SCHEMATIC REVIEW – APPROVED

RE: QUIZNOS SUB
Byram Business Center #5989
102-106 Byran Business Center
Byram, MS 39272

5989 SCHEMATIC
SUITE 114 & 116
1990S.F. TOTAL
Scale 1/4" = 1'-0"

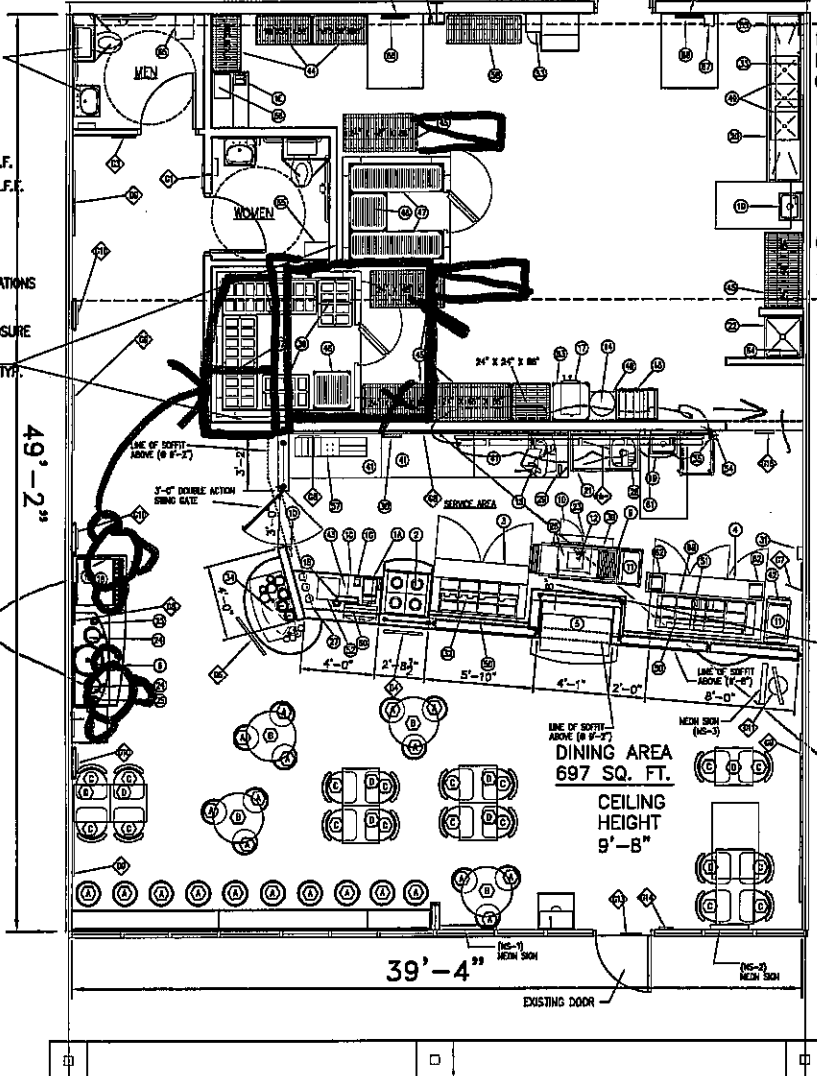
- g. **Remote compressors noted per the schematic. Verify.**
 - h. **A 9'-6" high freezer is standard. Please complete the Kolpak worksheet and return it to our office. Construction documents will not be reviewed until the Kolpak worksheet has been received by the design and construction department.**

- i. A 240V toaster is noted on the schematic. Verify.
 - j. NOTE: The electric panel **must** be noted (**EXISTING**) on the construction drawings. If not noted on CD'S then a new electric panel will be ordered regardless.

- a. The back room has too much room, move the Freezer wall forward and place the beverage counter where indicated as per attached.
- b. Place possible round tables or Two Top where the beverage counter was, see attached.
- c. Move Menu closer to the front, see attached.
